Access Compliance Report Public Rights-of-Way (Curb Ramps)

Main Street: 1ST_ST Cross Street: MAIN_ST Location: SE

ADA ID: RPRK211026172708 Ramp Type: Type 4 - Parallel Initial Pass/Fail: Fail Overall Compliance: No Severity Score: 2

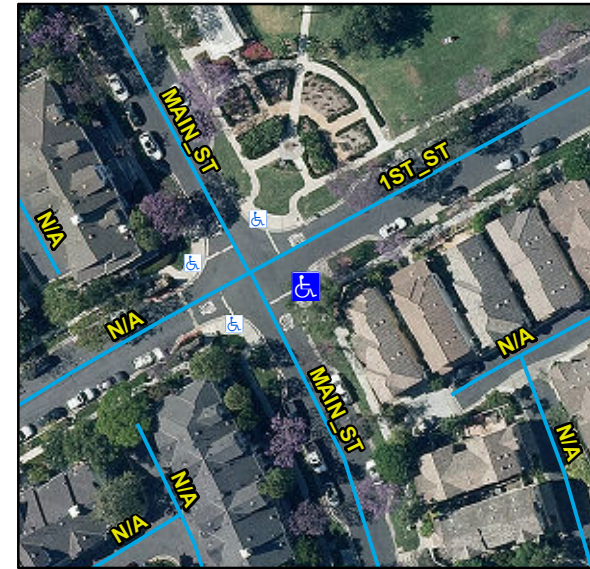
OC Std/PROW:
R204.3, R304.5.3, STD 1115

Compliance	Description	Data	Compliance	Description	Data
N/A	Ramp Length LT (in)	104	N/A	Ramp Length RT (in)	104
Yes	Ramp Width LT (in)	89	Yes	Ramp Width RT (in)	89
Yes	Ramp Run Slope LT (%)	2.2	Yes	Ramp Run Slope RT (%)	4.2
Yes	Ramp Cross Slope LT (%)	2	No	Ramp Cross Slope RT (%)	2.6
N/A	Landing Present	N/A	N/A	DWS Provided	N/A
N/A	Landing Length (in)	N/A	N/A	DWS Contrast	N/A
N/A	Landing Width (in)	N/A	N/A	DWS Length (in)	N/A
N/A	Landing Run Slope (%)	N/A	N/A	DWS Full Width	N/A
N/A	Landing Cross Slope (%)	N/A		DWS Offset Type	N/A
N/A	Landing Movement Obstructed?	N/A	N/A	DWS Offset Left (in)	N/A
	Landing Movement Type	N/A	N/A	DWS Offset Right (in)	N/A
N/A	Landing Shared	N/A			
N/A	Clear Space	Yes			
N/A	Clear Space To Crosswalk (in)	N/A			
N/A	Marked Crosswalk 1	No	N/A	Marked Crosswalk 2	No
	Crossing 1 Direction	N		Crossing 2 Direction	W
	Marked Crosswalk 1 Width (in)	N/A		Marked Crosswalk 2 Width (in)	N/A

Possible Solutions:
Remove & Replace Curb Ramp With Two New Directional Ramps or Equivalent.
